This Service Information bulletin supersedes SI M51 08 12 **dated August 2012**.

Rattling Noise from the Tailgate

R58

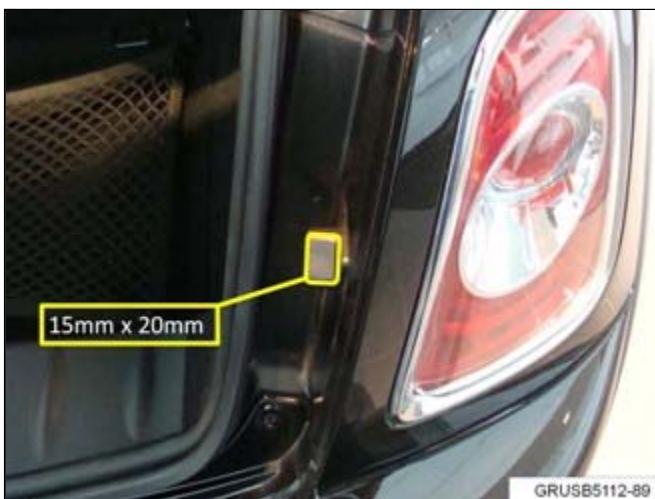
2. If the felt tape on the bump stop is mis-shaped or missing, it must be replaced.

3. This close-up view shows the existing felt is mis-shaped and it will eventually fall off.

4. **NEW** Clean off the mating surface of the bump stop with a suitable cleaner. Cut a new piece of sliding tape (83 19 9 407 798) approximately 15mm by 20mm and apply to the flat area of the rubber bump, as shown. Trim off any excess tape with scissors. Repeat the same repair procedure for the opposite side.
